**Illinois Tollway Base Sheet Revisions**

Section M		Base Sheet Drawings	
Drawing	Modification Summary	Effective: 03-01-2026	
<b>Plaza Electrical Work (Business System)-Series 2500</b>			
<b>M-BUS-2503</b>	<b>Single Line Power Diagram</b>

VERSION: 2026-03      BASE SHEET: M-BUS-2503      SHEET: 1 OF 1

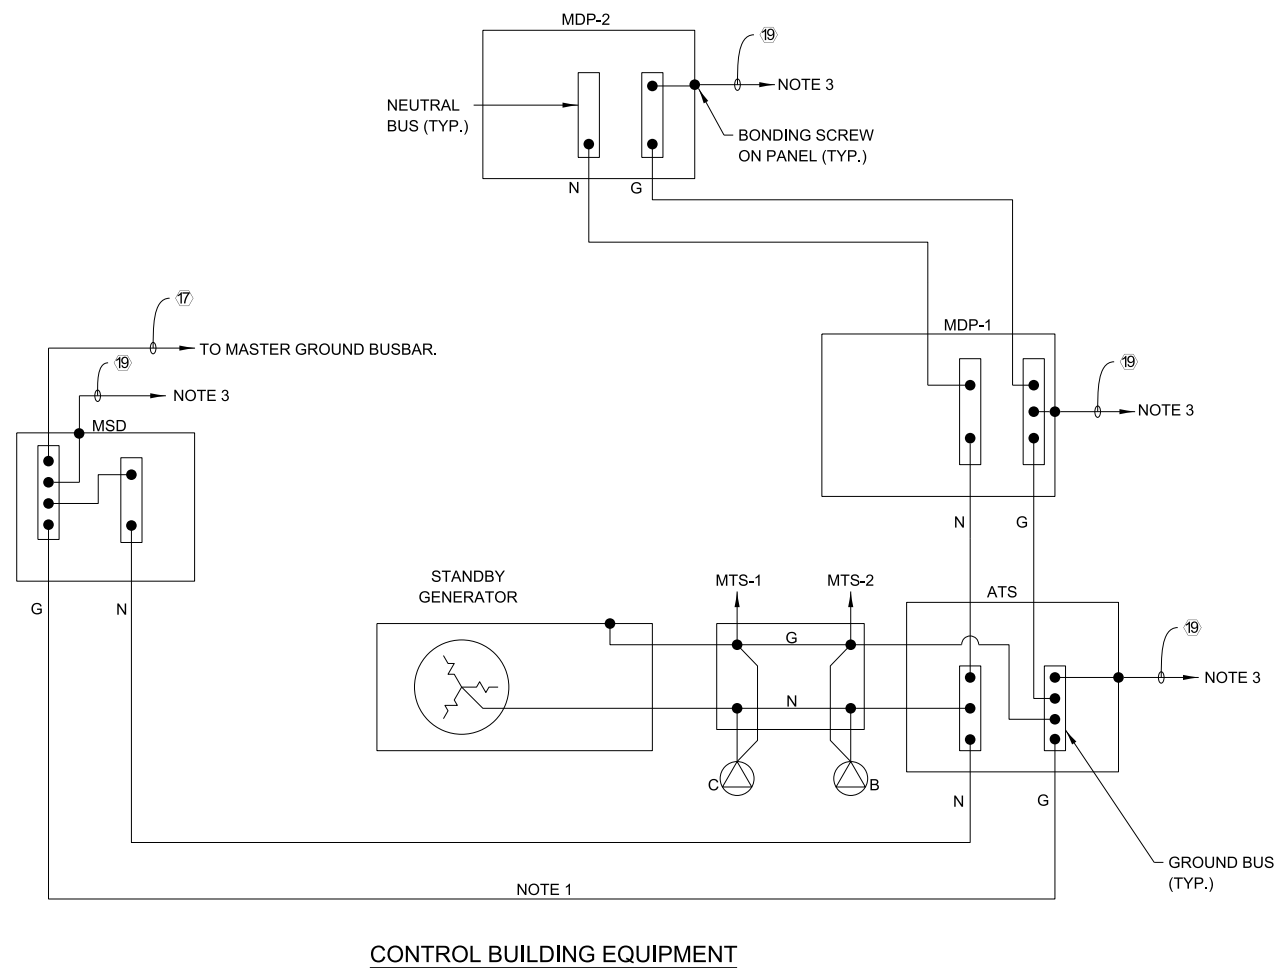
Sheet 1	Revised size circuit breakers from 30A/2P to 50A/2P		
	Revised size circuit breakers 30A/1P to 30A/2P		
	Changed identification to ITS-1 Panel		
	Changed power cable type between main breaker service to Automatic transfer Switch: changed to cable Type 137		
	Updated single line diagram for MDP-1		
	Removed Line Conditioner identification on line diagram		
<b>M-BUS-2509</b>	<b>Exterior Elevations - Main Plaza</b>

VERSION: 2026-03	BASE SHEET: M-BUS-2510	SHEET: 1 OF 1
---------------------	---------------------------	------------------

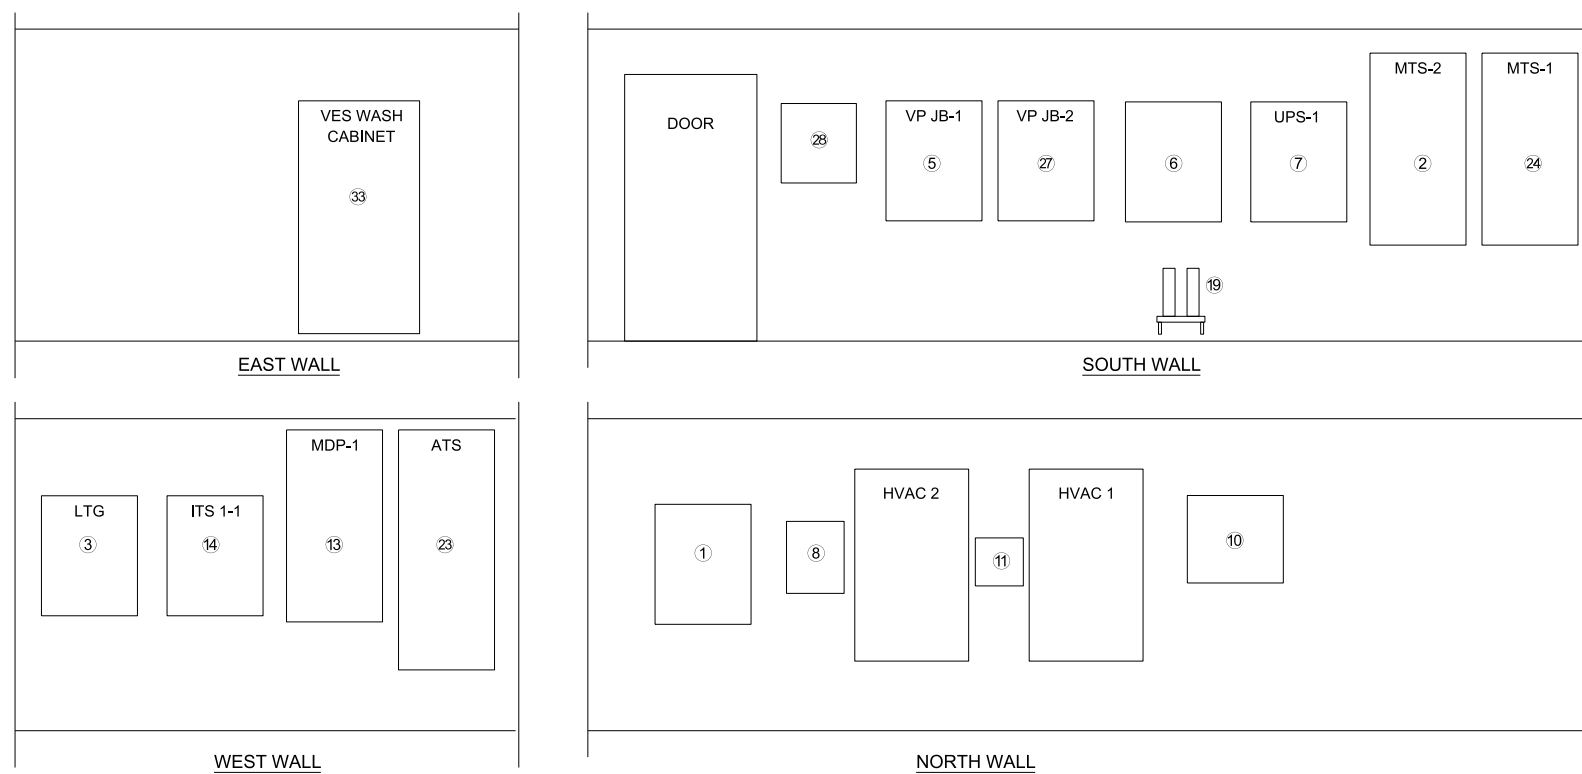
Sheet 1	Added a clearance of 18 in between HVAC 1 and HVAC 2		
<b>M-BUS-2510</b>	<b>Control Building Equipment Layout - Main Plaza</b>		
Sheet 1	Connected loose conduit to ITS Panel 1-2 ITS (Item 39)		
	Tag 38 was incorrectly identified as Tag 38 but shall be identified as Tag 37 as 5KVA transformer

Item 34 air compressor has been removed since there is a compressor to compress nitrogen gas into gas tank		
	Changed power cable type between main breaker service to Automatic transfer Switch: changed to cable Type 137		
	Revised legend for Item 19 to say: Free Standing UPS (4KVA)		
<b>M-BUS-2511</b>	<b>Interior Elevations - Control Building</b>

VERSION: 2026-03	BASE SHEET: M-BUS-2515	SHEET: 1 OF 1
---------------------	---------------------------	------------------

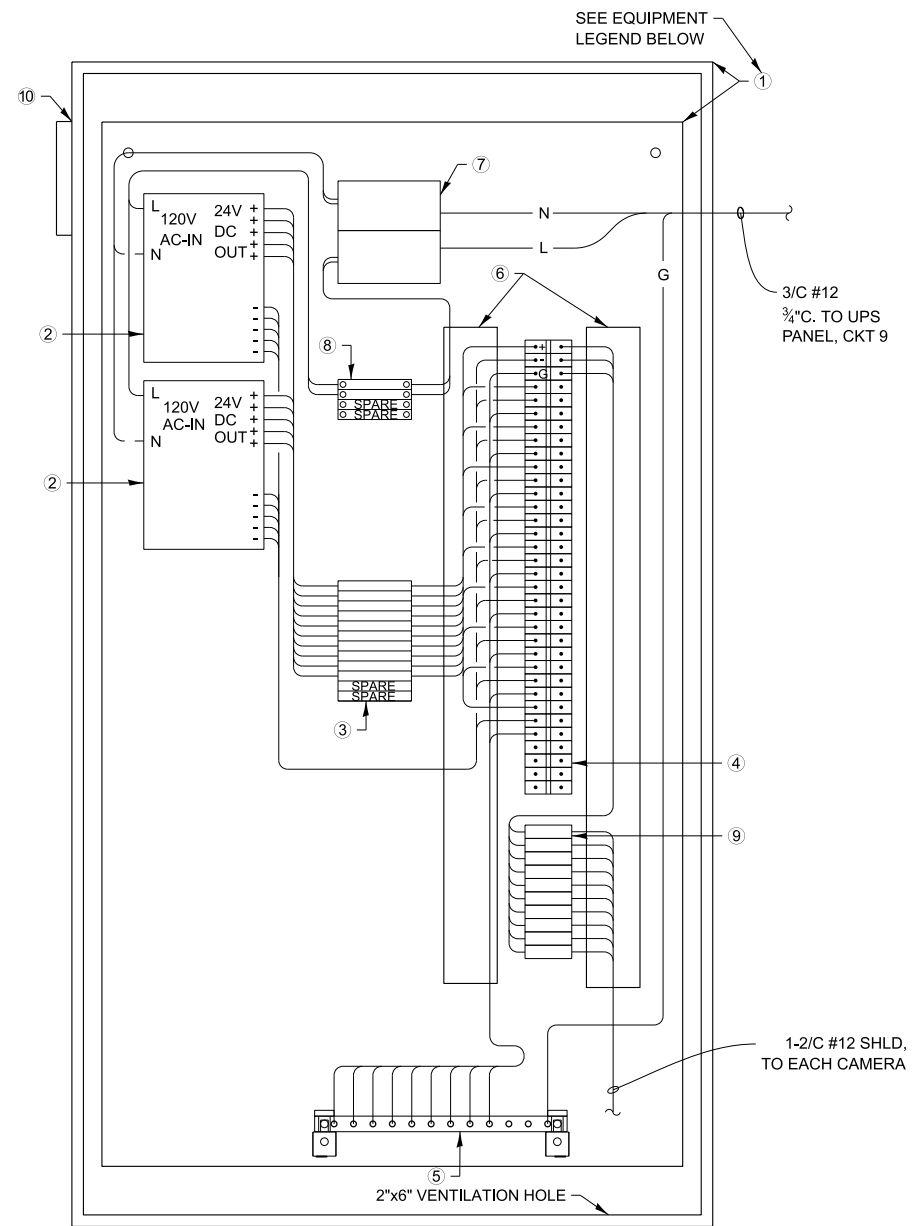
Sheet 1	For MDP-1: revised loads for Phase A, Phase B and Phase C		
	Separated HVAC 1 and HVAC 2 with their respective loads for Phase A, Phase B and Phase C with 50A/2P breaker for each HVAC unit		
	Updated subtotal power values for Phase A, Phase B and Phase C

VERSION: 2026-03      BASE SHEET: M-BUS-2516      SHEET: 1 OF 1

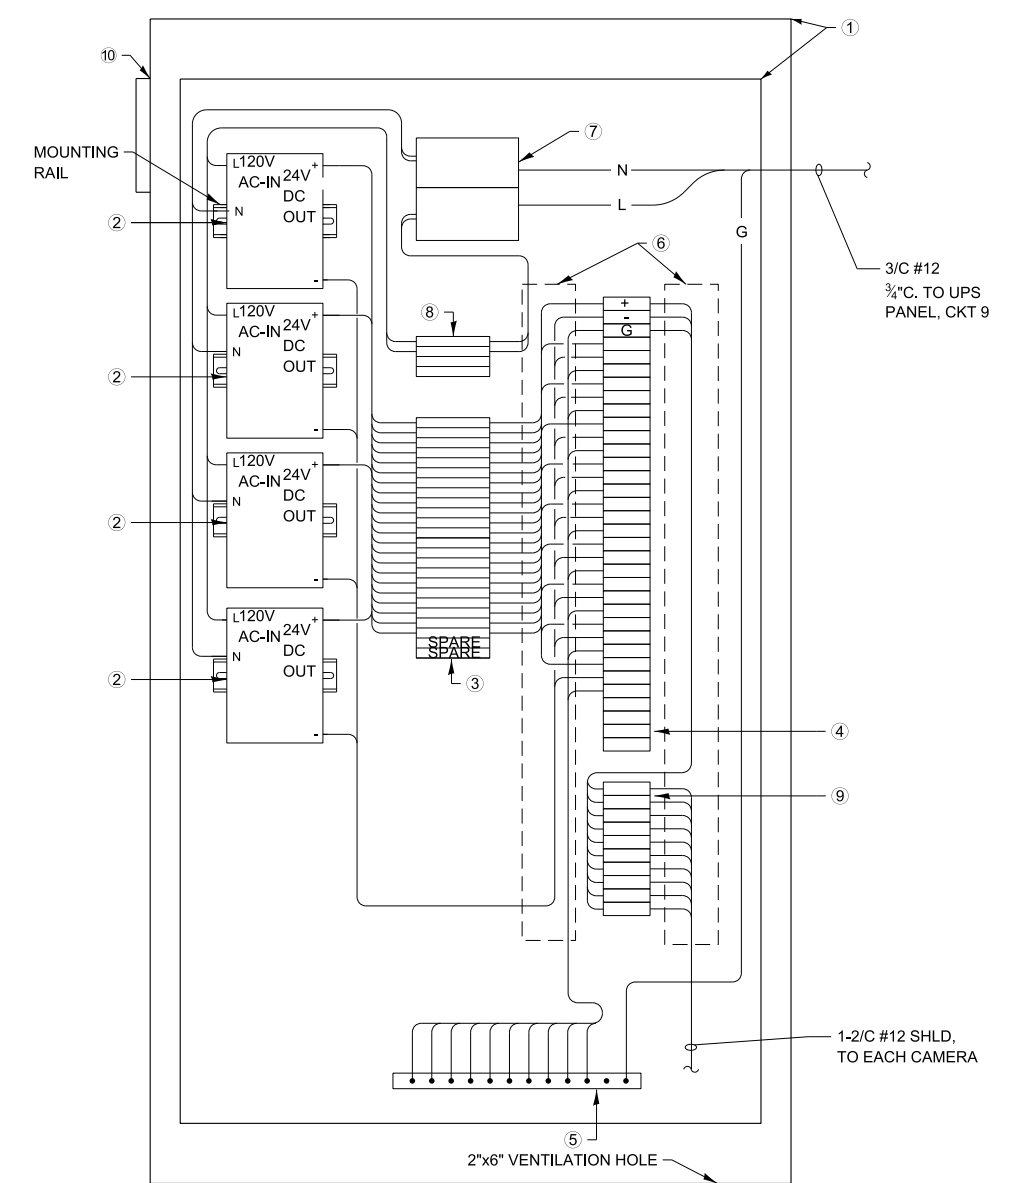
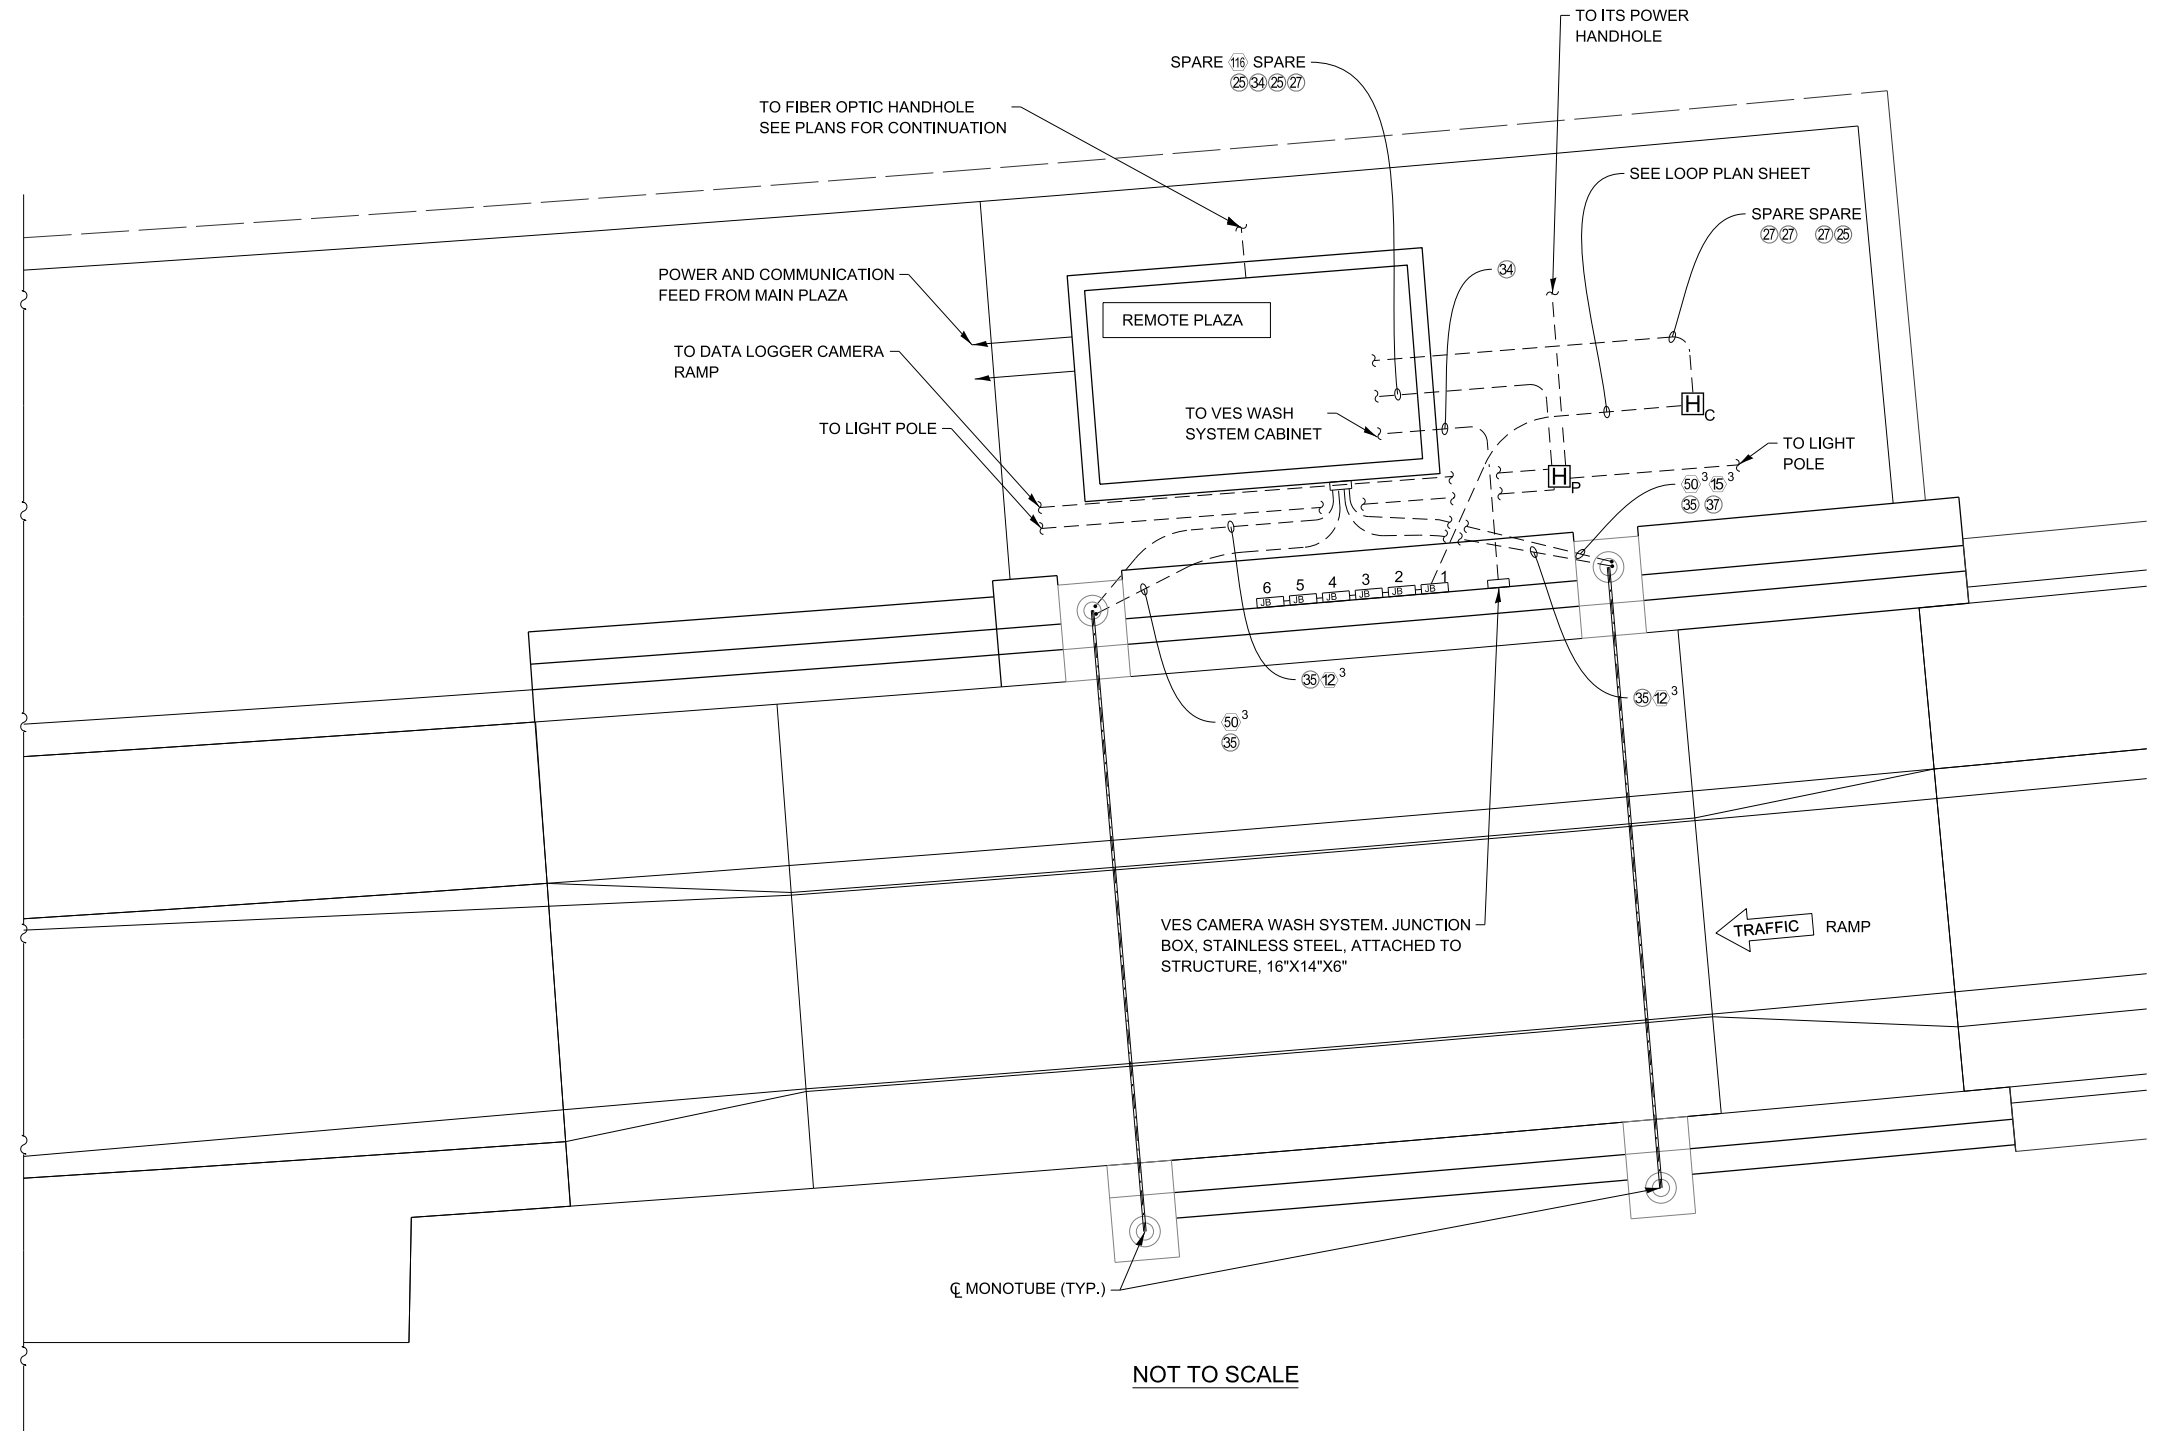
Sheet 1	Revised Item 1 (at 2 locations on the drawing) enclosure model number: use Hoffman model # A-482408LE with white panel		
<b>M-BUS-2518A</b>	<b>Loop Plan - AET 3-Lane Layout</b>

**LOOP PLAN - AET 1-LANE LAYOUT SINGLE MONOTUBE**

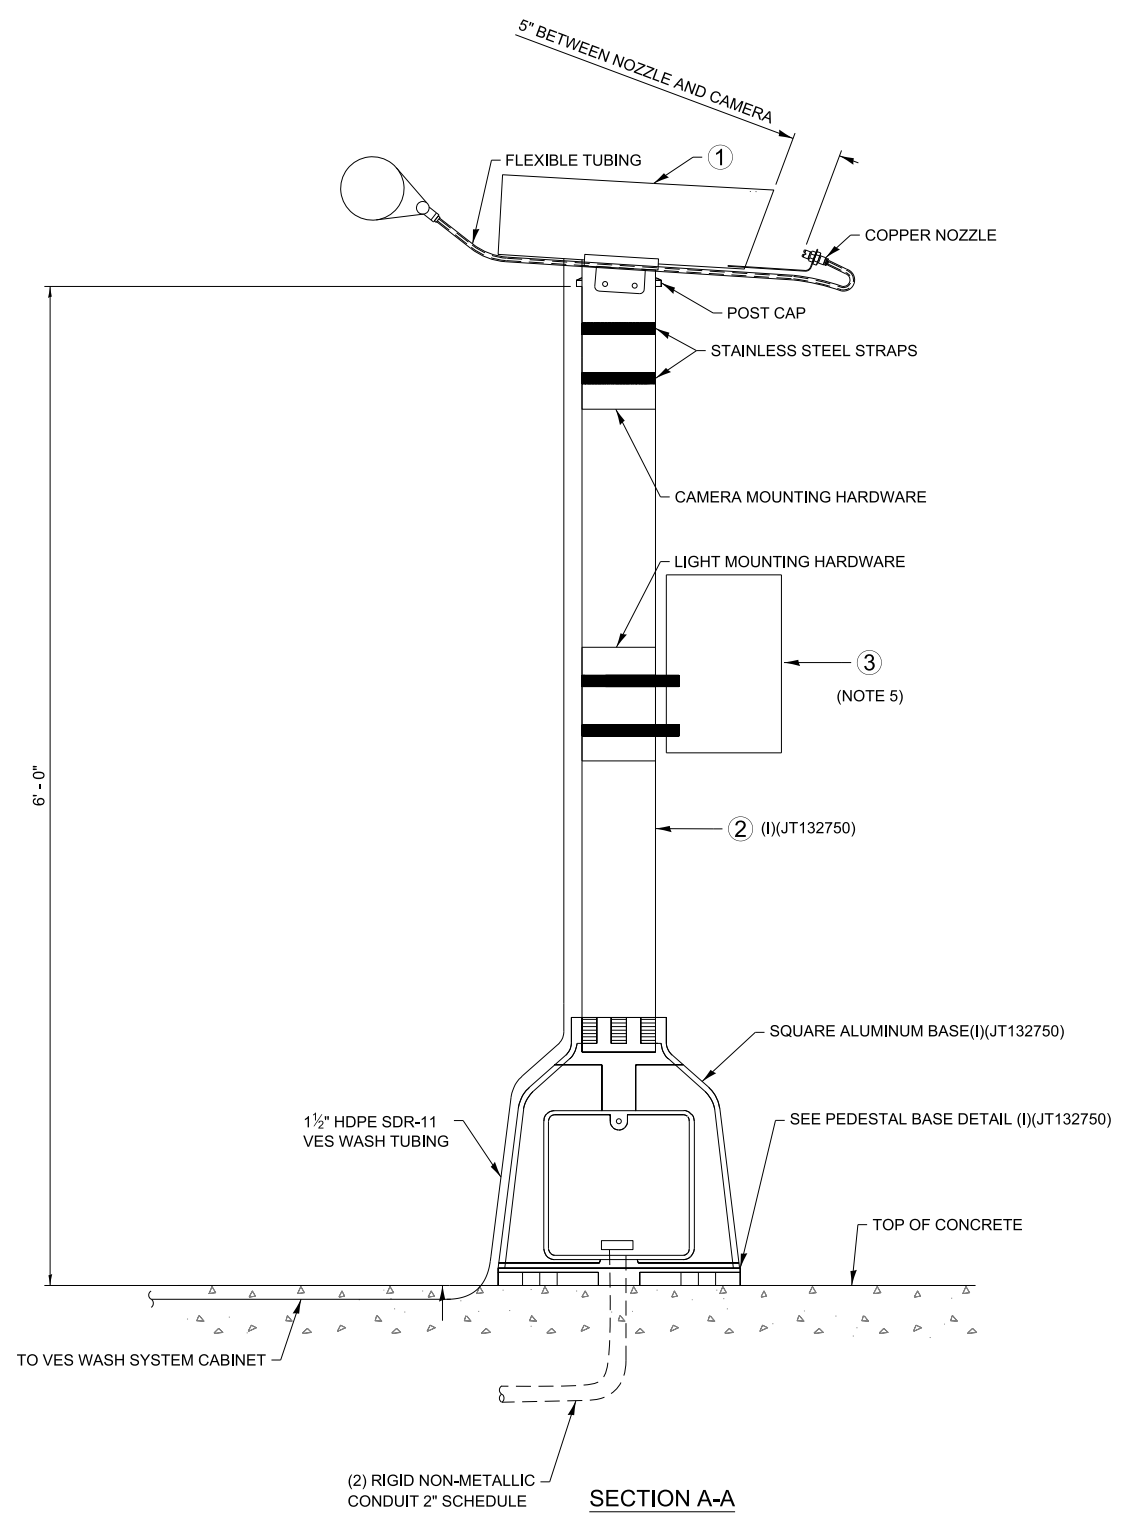
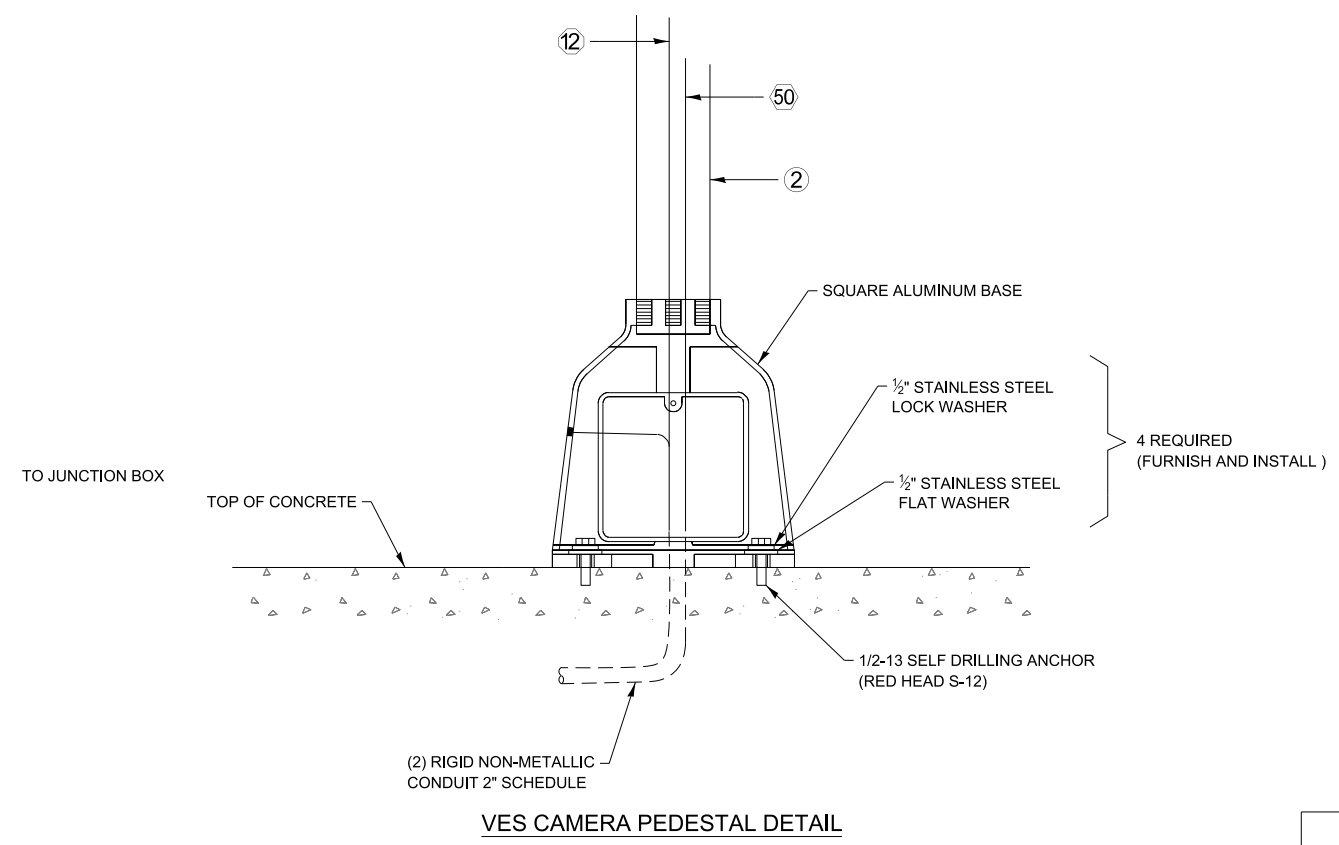
Sheet 1	Drawing revised to show the installation details for a mounting box to be installed at the top of the vertical segment of the monotube		
	For VES Wash conduit: conduit to be one continuous piece when embedded - no splice allowed		
	Revised size of 1" to size 1 1/2" PVC coated RGS conduit		
<b>M-BUS-2518D</b>	<b>Ground Mounted VES Camera With VES Wash Tubing</b>
